Request for Proposals: Instructions to Proposers

Addendum #1 ~~Original Issue~~

Town of Grand Chute, College Avenue

Design-Build Project

EXHIBIT 11-A TYPICAL FINISHED SECTIONS

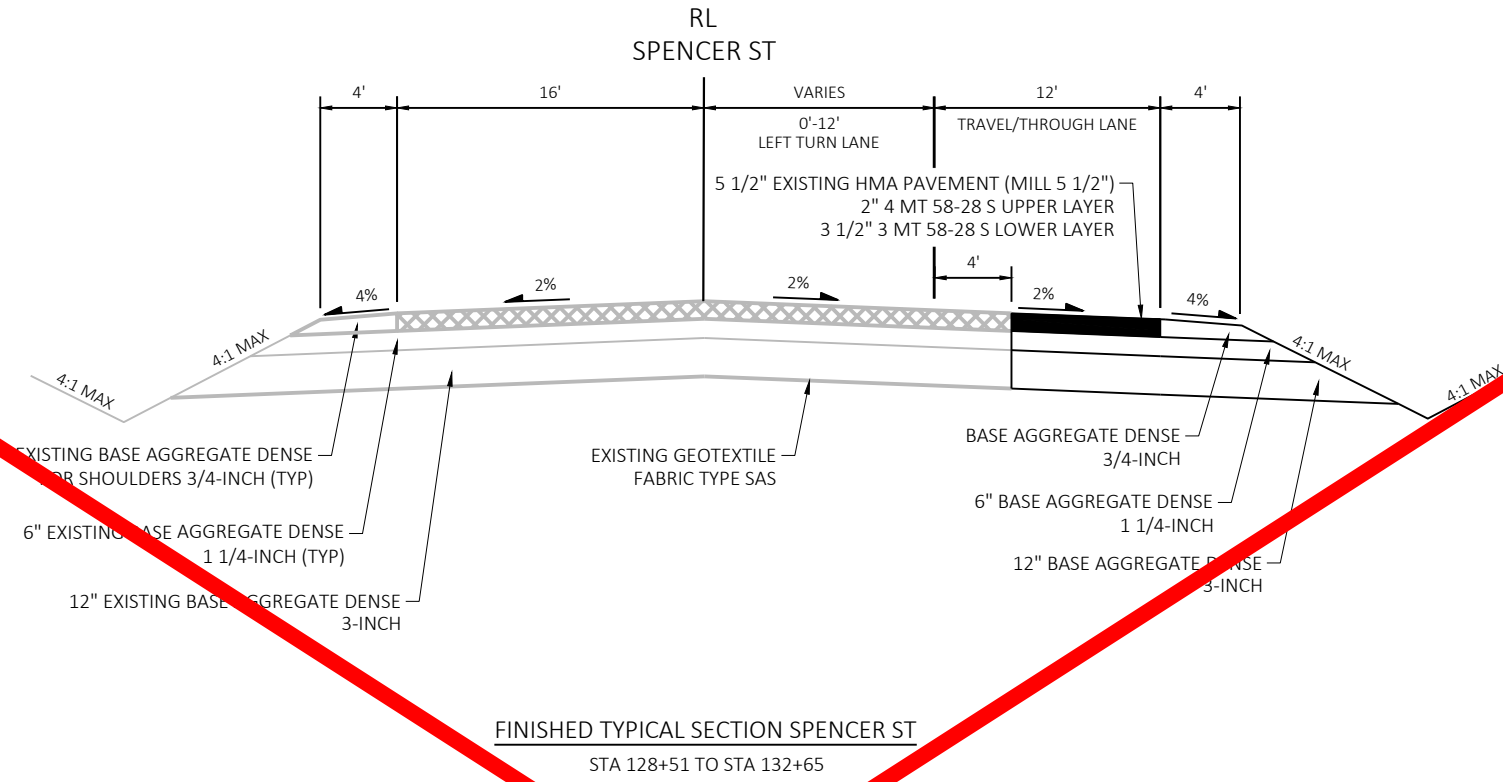
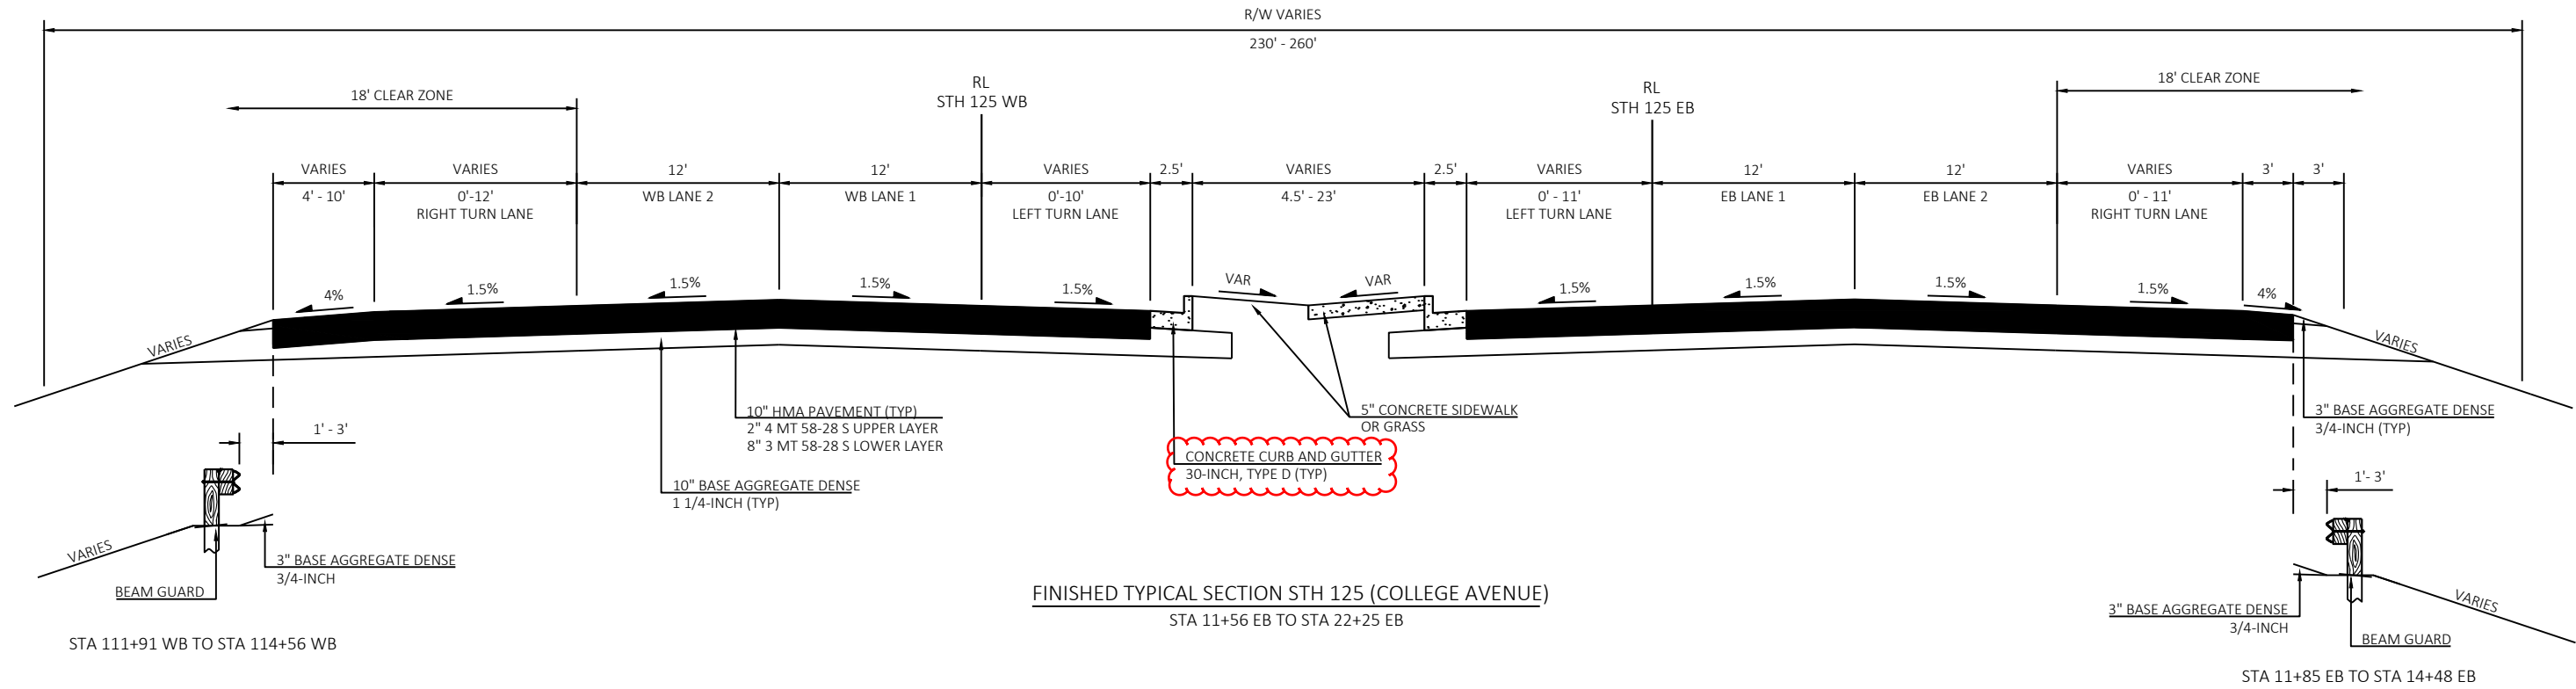
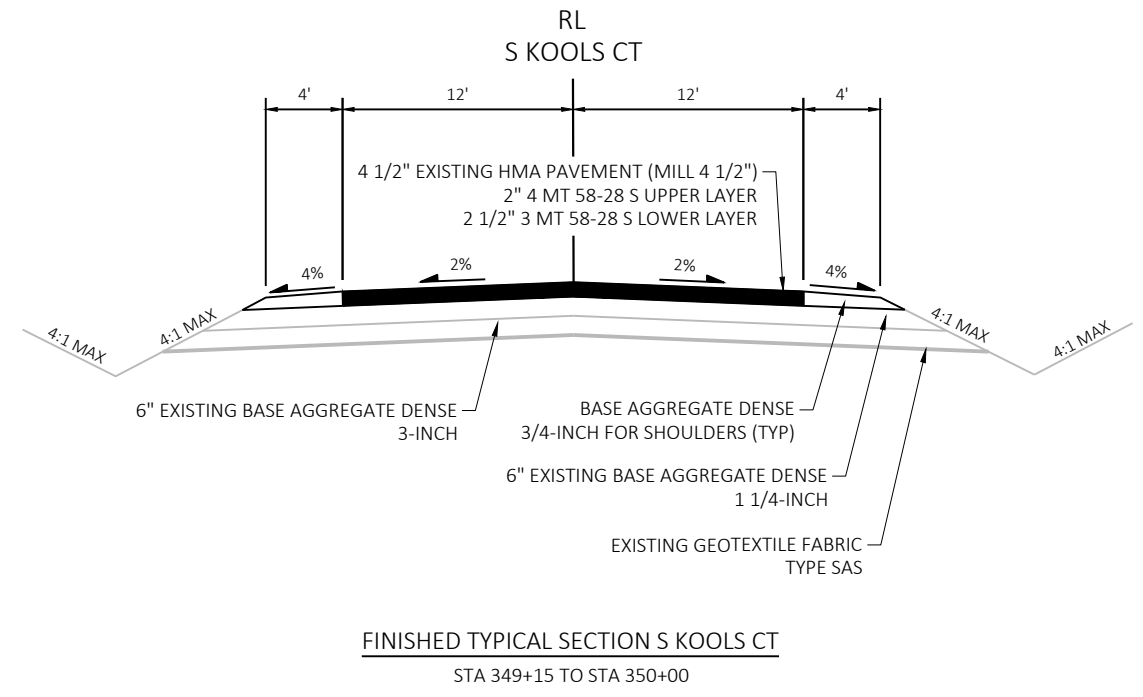
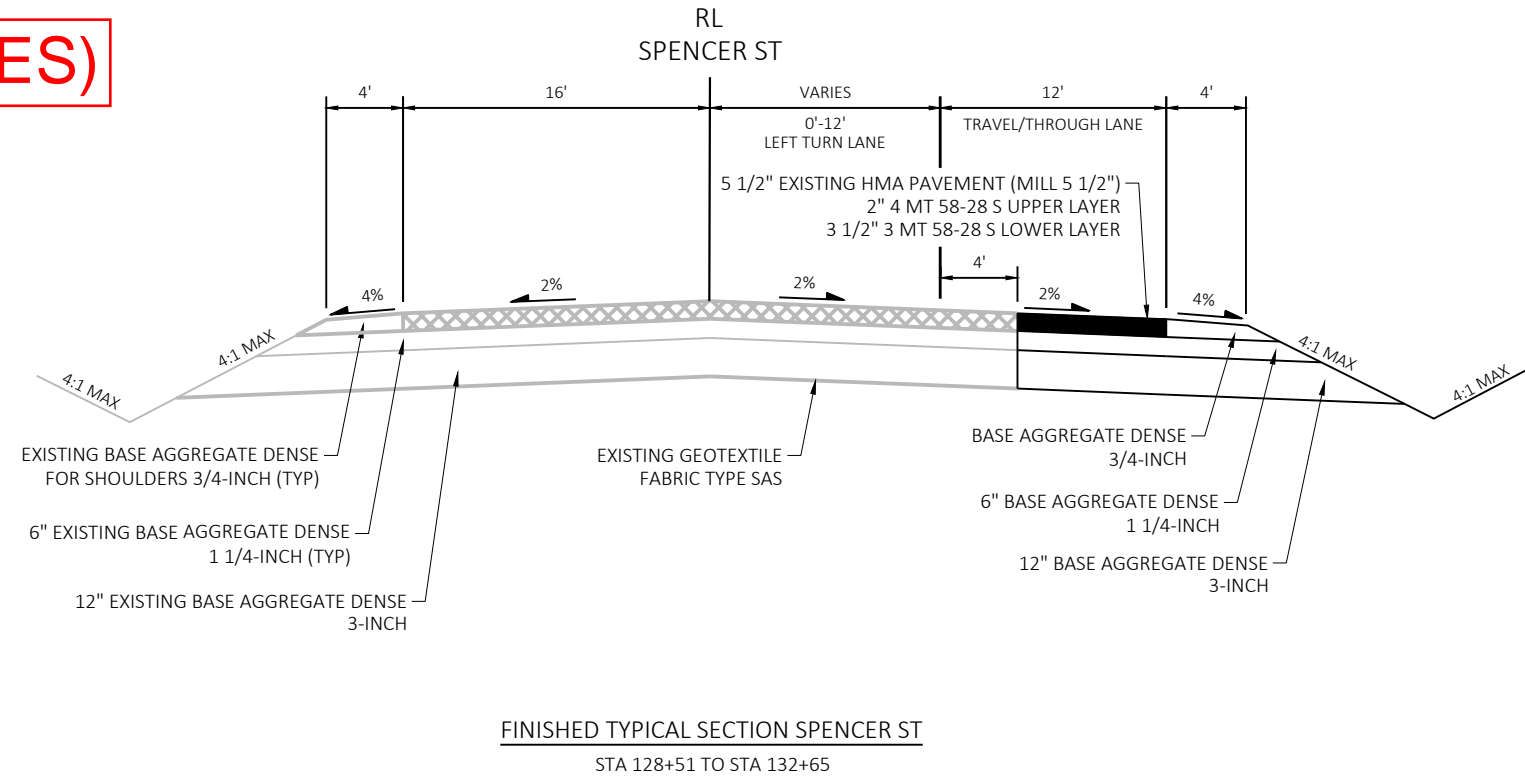
REPLACE (NO CHANGES)
